New Disc Material series KG9/7 and KG6/8

Disc-Material has changed from **1.4408** to **1.4517**

KG9 with new disc material

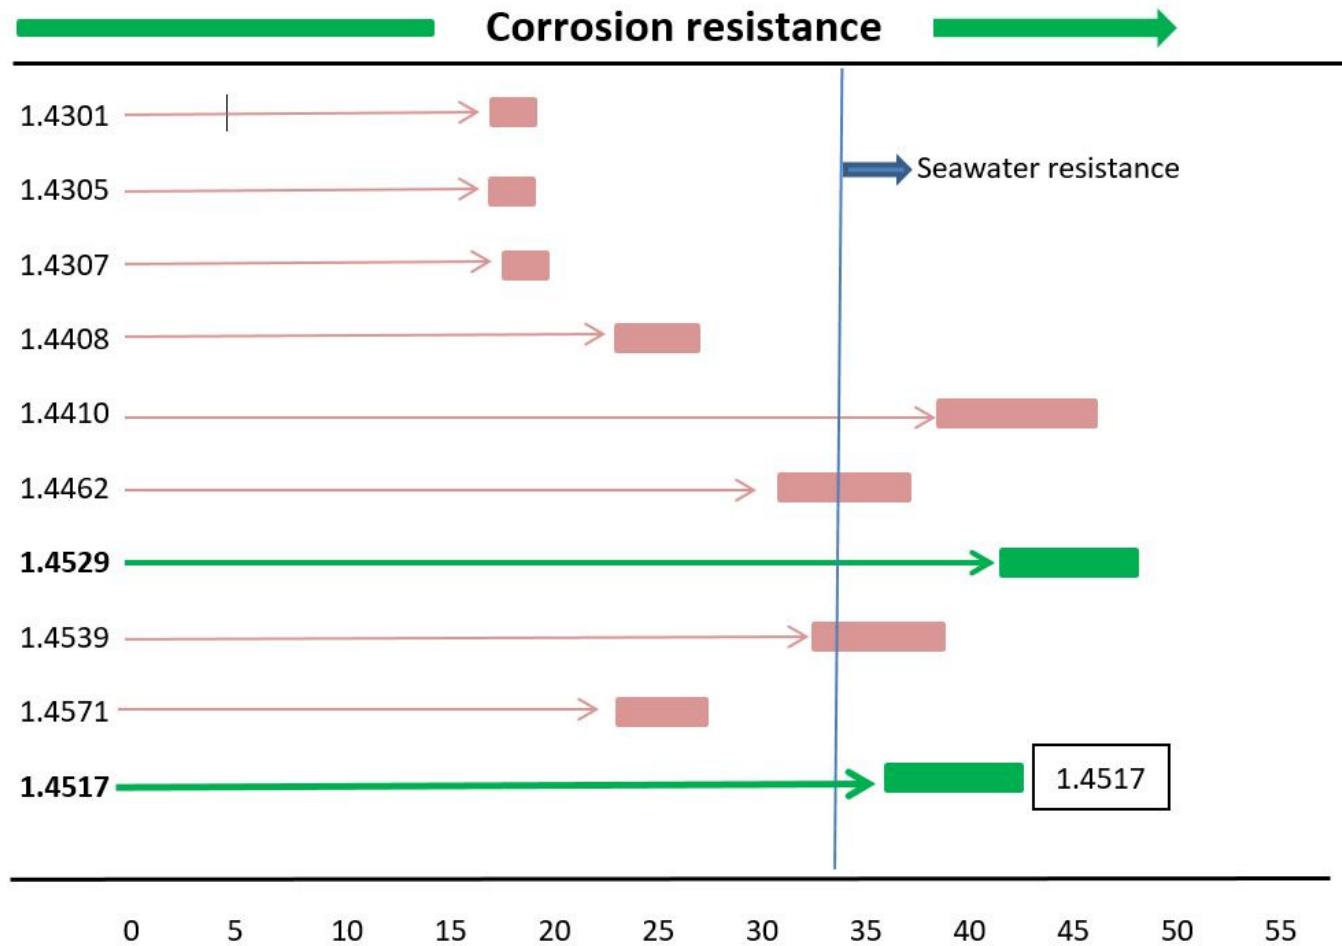
It's **1.4517**
and 
not 1.4571

KG6/8 disc polished with charge no. on the square

More yield strength:

1.4408 $R_{p0,2} = 185 \text{ MPa}$

1.4517 $R_{p0,2} = 480 \text{ Mpa}$

More corrosive resistance:

1.4408 PRE = $\emptyset 25$

1.4517 PRE = $\emptyset 39$
